RECOMMENDED TECHNICAL SPECIFICATIONS MARK UPS

Attachment 1 to AEP-90-231

NS-OPLS-OPL-11-90-463

Figure 2.1-1 Reactor Core Safety Limits
Four Loops In Operation

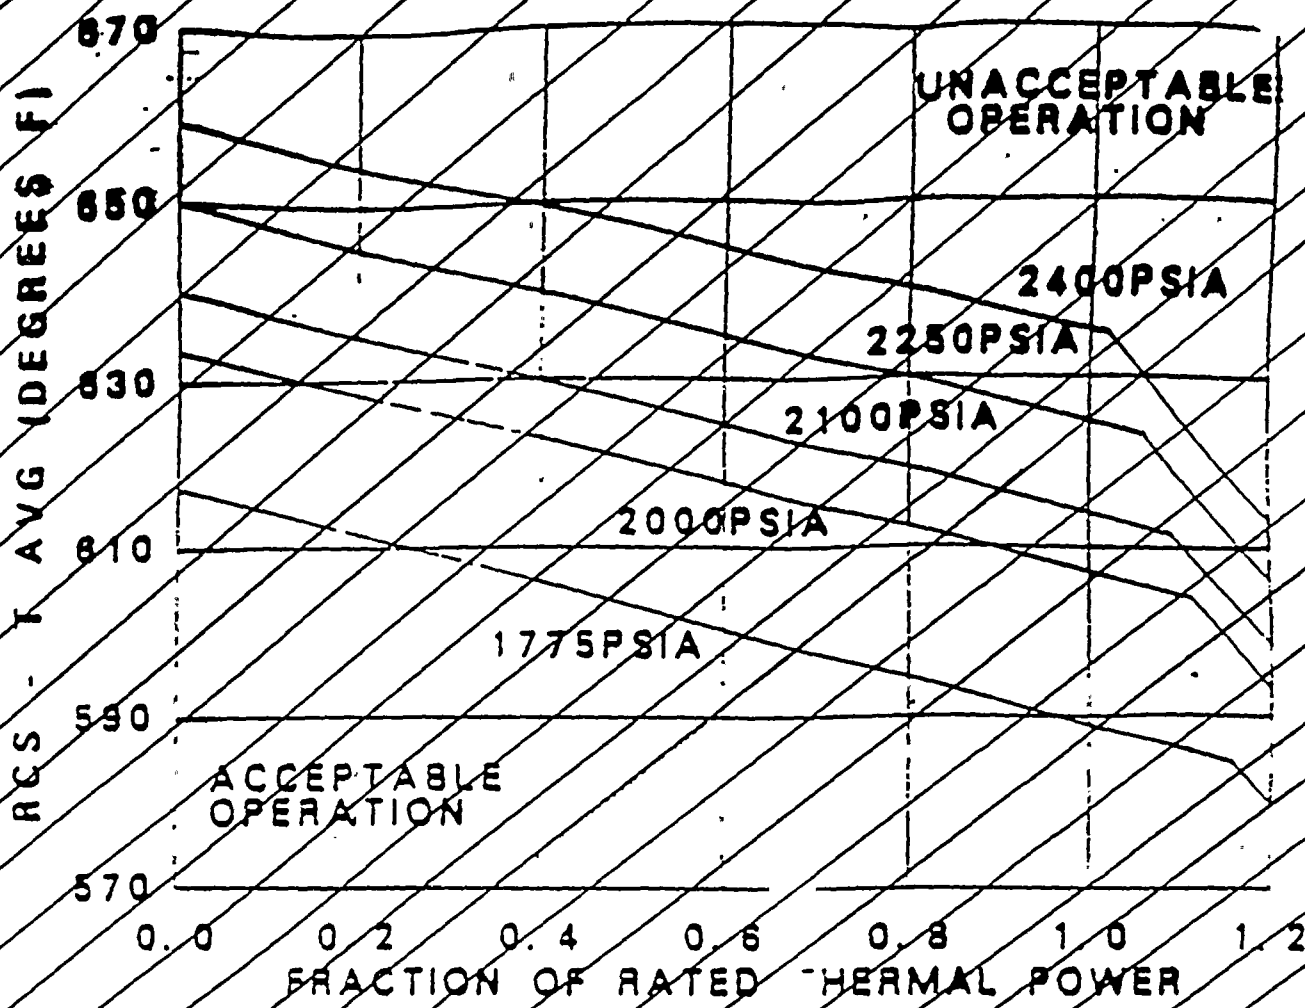
Replace with supplied figure

| PRESSURE (PSIA) | BREAKPOINTS FRACTION RATED THERMAL POWER, T AVG IN DEGREES F |
| 1775 | (0.0, 617.1), (1.18, 584.5), (1.20, 579.7) |
| 2000 | (0.0, 632.5), (1.11, 603.9), (1.20, 592.1) |
| 2100 | (0.0, 640.3), (1.09, 611.5), (1.20, 598.3) |
| 2250 | (0.0, 650.0), (1.05, 623.2), (1.20, 606.8) |
| 2400 | (0.0, 659.0), (1.02, 634.8), (1.20, 613.0) |
